Warning Time for Extreme Precipitation Events

Rev 0 i, 6-4-14

Figure 1 Consequential Flooding Illustration

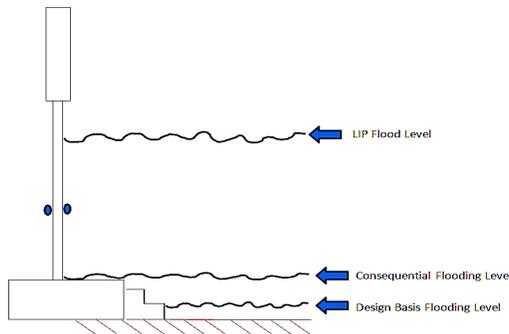
Comment [NRC Staff16]: The determination of what is consequential should be based on a site-specific basis. Consideration of aspects other than the SSCs being directly impacted by flood waters may be needed. Examples include but are not limited to: 1) ability to stage equipment or move around the site; 2) associated affects such as wind, lighting, and other factors such as personnel availability.
